ENCLOSURE

SAFETY EVALUATION REPORT ON
XN-NF-82-07, REVISION 1

"EXXON NUCLEAR COMPANY ECCS CLADDING SWELLING AND RUPTURE MODEL"

Figure 5

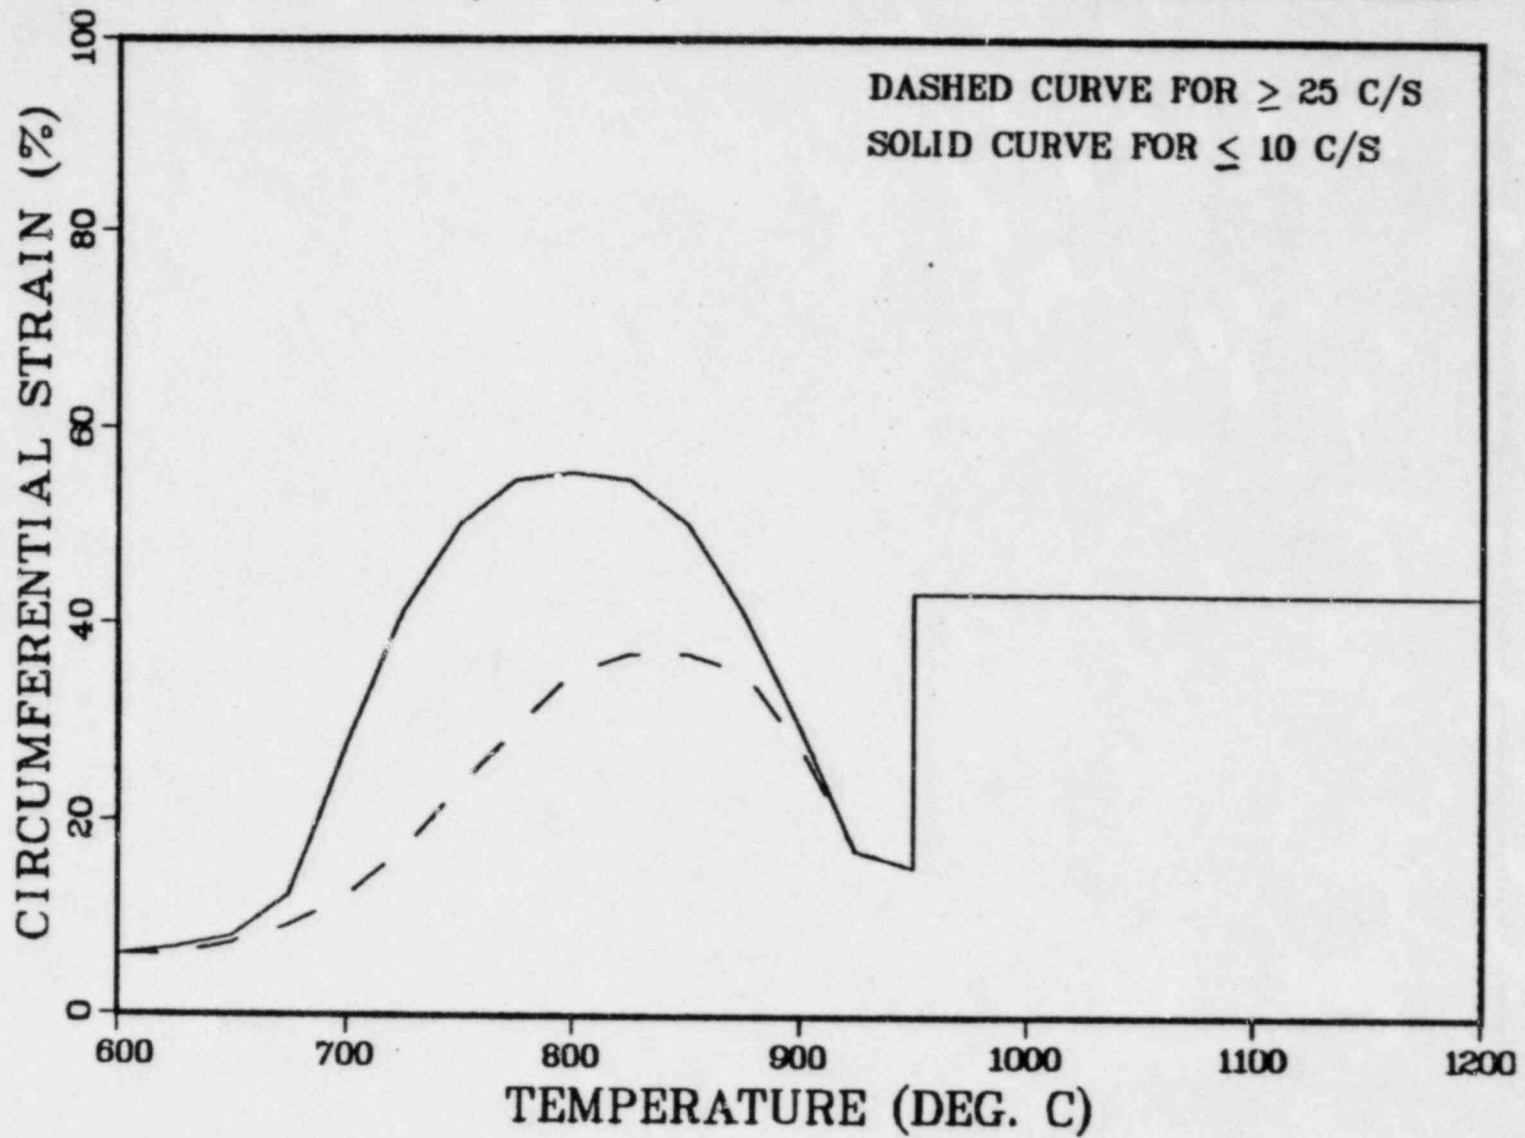
The second ENC HUXY burst strain model is shown in Figure 5. This model is used for oxide thinning and metal-water heat generation calculations for ruptured rods in the plane of interest. The oxidation calculations elsewhere along the fuel rods are performed using the prerupture strain model described in Section 2.4 and shown on Figure 2. The new version of HUXY calculates oxide thinning and oxidation heat generation both prior to and after the occurrence of rupture. It is thus an improvement over the old version of HUXY, which did not model oxidation effects prior to rupture.

As with the other HUXY strain model shown in Figure 4, this model as shown in Figure 5 is also a modified version of the model shown in Figure 3. Specifically, this model is a 0.614 reduced-scale version of that given in Figure 3. Exxon states that the basis for this reduction in the degree of strain is derived from the FLECHT tests in which the linear strain averaged over 3 inches on ruptured rod burst lobes was 61.4% of the maximum strain. Exxon uses a span length of 3 inches because of the Appendix K requirement for evaluation models to calculate cladding inside oxidation over a 3-inch axial span that is centered at the burst location. Furthermore, Exxon assumes that the metal-water heat generated on fuel rod surface areas larger than that corresponding to the surface area equivalent to a condition of rod-to-rod contact is lost due to convective heat transfer. The basis for this assumption

is derived from the empirical analysis of unreferenced ENC spray cooling tests. The relevancy of the Appendix K requirement to axial strain averaging and the appropriateness of the excess convective loss term are both questionable to us, but they do not require explanation in light of the results from additional LOCA sensitivity studies ENC has performed.

Those sensitivity studies were performed on an 8x8 BWR fuel assembly in which the 4 center rods were allowed to rupture in the plane of interest. For one case, the ratio of average to maximum strain was 0.462; and for the other case, the ratio was 0.614. (For this example, the absolute magnitude of the difference in coplanar strain was 11%.) The net result from the calculations was that the later case with the higher strain ratio yielded 11°F higher PCT and 0.1% higher LCO. Though the more greatly deformed bundle produced a more limiting result, the degree of the effect was small. And once again, this trend is similar to that calculated by General Electric (Ref. 10)

Consequently, we approve this ENC strain model used for BWR oxidation calculations on the basis of the reported small evaluation model sensitivity to strain rather than on the basis of its realism.

Figure 6

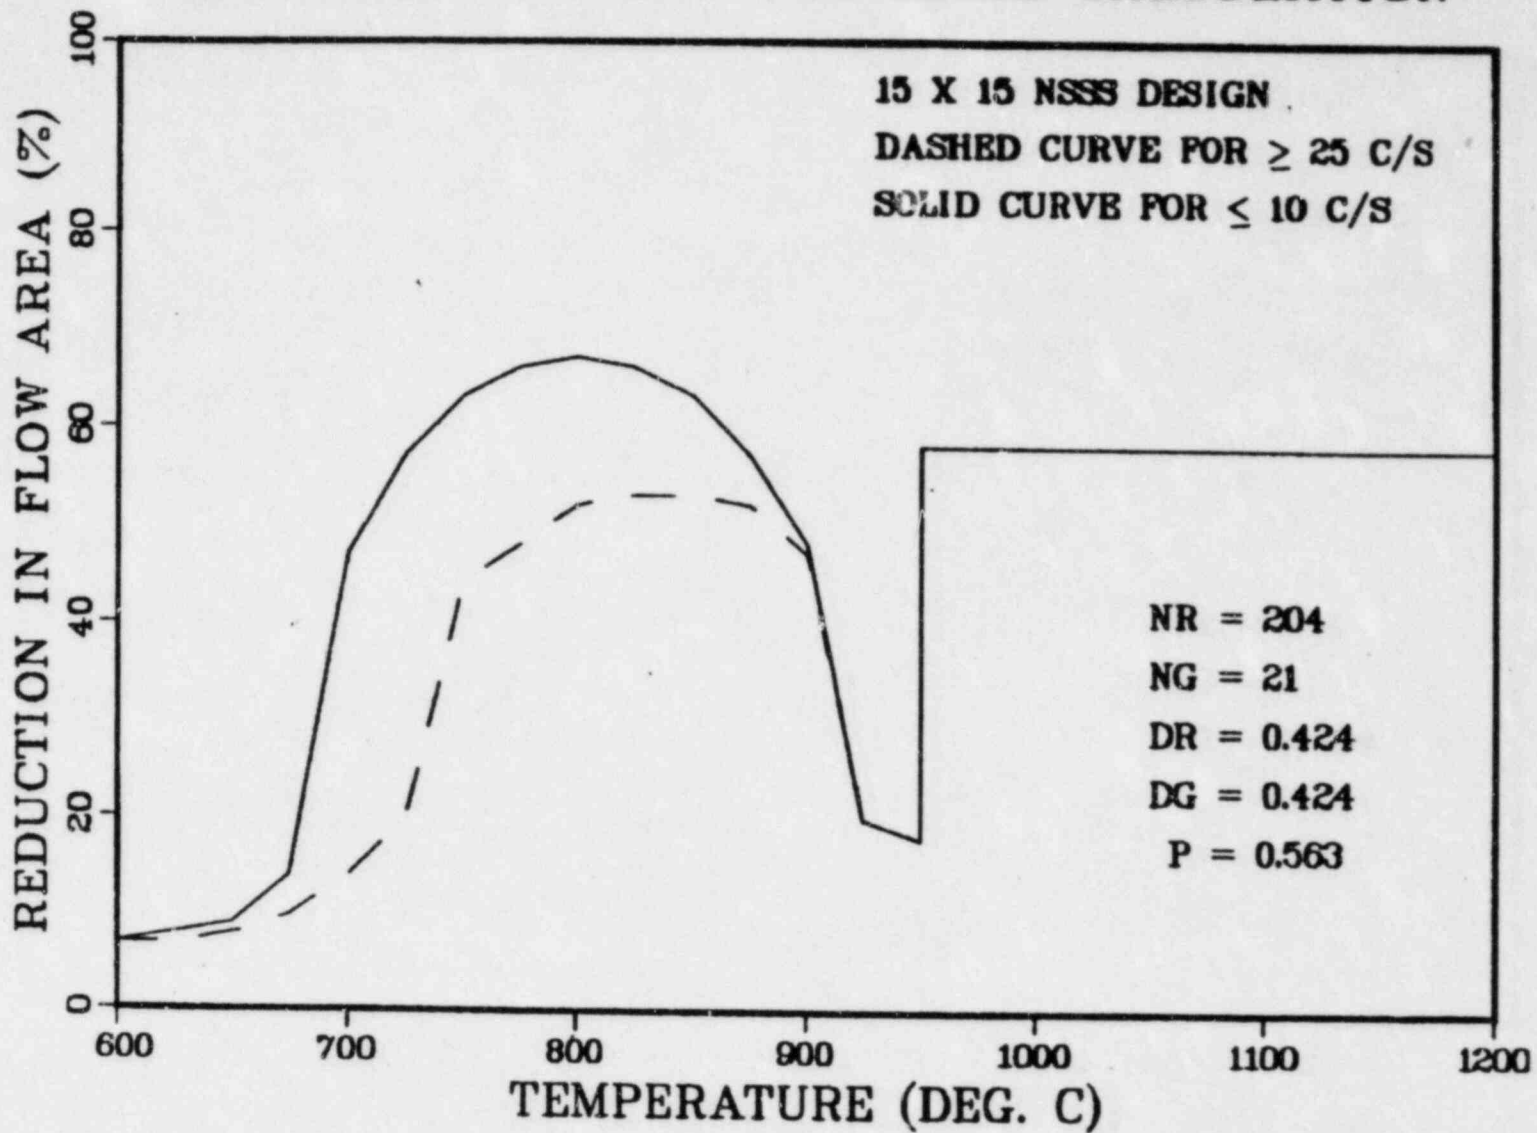
The Exxon methodology for calculating PWR fuel assembly flow blockage is the same as that described in NUREG-0630. The only differences in the ENC model are use of (a) a new modified burst strain model (discussed previously and shown in Figure 3), and (b) an NSSS-design-specific scaling factor to account for the beneficial presence of non-fuel elements (i.e., guide and instrument tubes) in the fuel assembly. With regard to the latter difference, the NUREG-0630 method employed an averaged scaling factor. Other aspects of the model, such as the empirical coefficient used in the determination of average coplanar strains are unchanged.

Exxon has provided an example calculation of the flow blockage that would be predicted for ENC 15x15 reload fuel in a PWR NSSS plant subjected to a design-basis large-break LOCA. That example is shown in Figure 6.

We conclude that the ENC flow blockage model does not underestimate the degree of blockage and is hence acceptable.
